AGENDA
FARRAGUT MUNICIPAL PLANNING COMMISSION

September 15, 2016
7:00 p.m. Farragut Town Hall

**MINUTES
FARRAGUT MUNICIPAL PLANNING COMMISSION**

REPORT TO THE FARRAGUT MUNICIPAL PLANNING COMMISSION

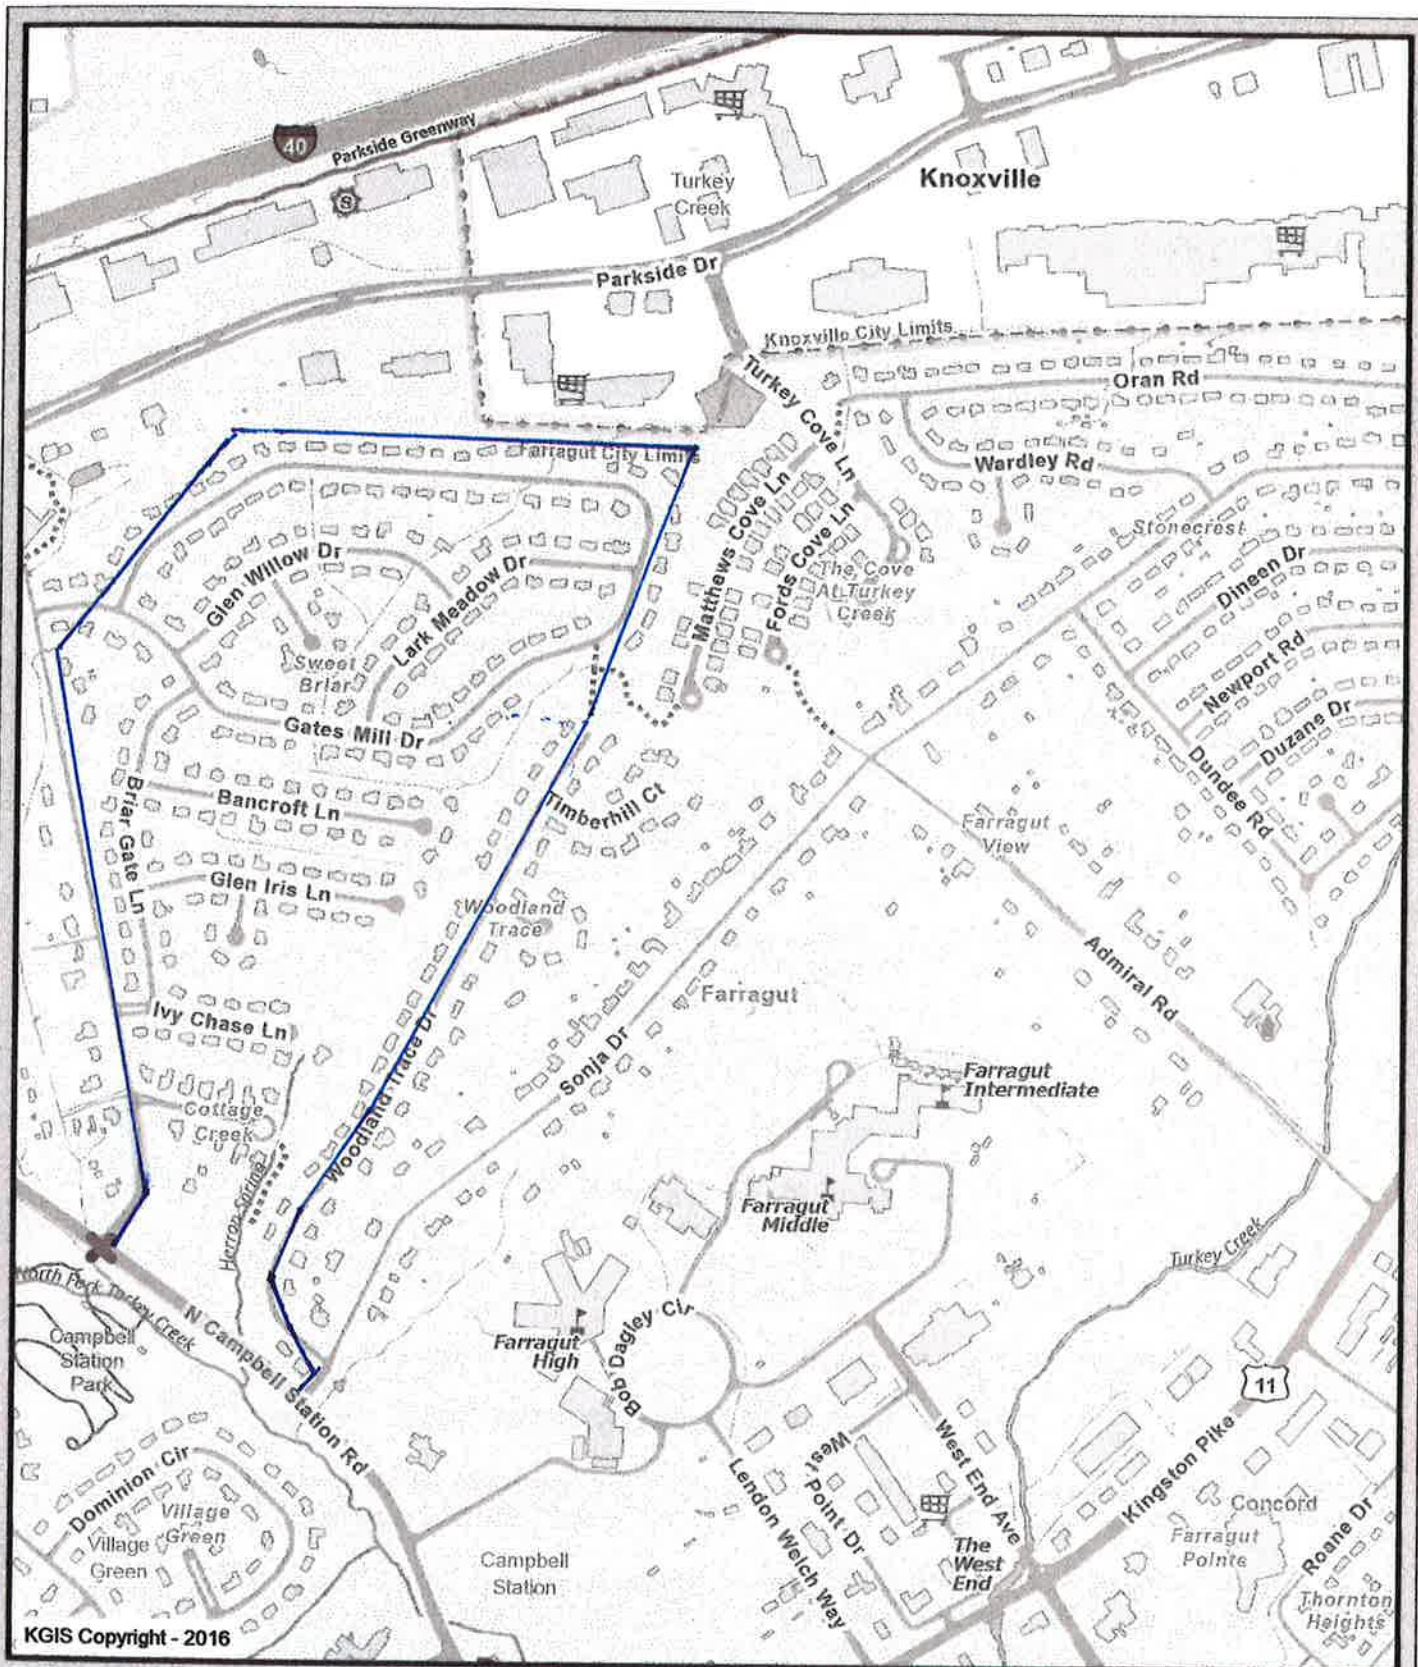
1. There appears to be grading in the aquatic buffer where the trail parallels the stream. Please revise accordingly;
2. Please submit a specific detailed plan for erosion control measures for this subarea of the plan, specifically for all disturbances within the aquatic buffer;

3. Please submit a bridge detail that is specifically designed for this project;
4. In accordance with the adopted Flood Damage Prevention Ordinance, please submit a "no-rise" certification by a Tennessee registered professional engineer to demonstrate that the cumulative effect of the proposed development, when combined with all other existing and anticipated development, will not increase the water surface elevation of the base flood at any point within the locality and please include the Hec-Ras output supporting the certification;

5. Please show where the trail is connecting to the development;
6. The delineation for the aquatic buffer appears to disappear on the lower portion of the stream on the north side of the stream. The end treatment cannot be within the buffer. Please remove this for the buffer;

7. Please ensure this plan is consistent with the remainder of the site plan sheets;
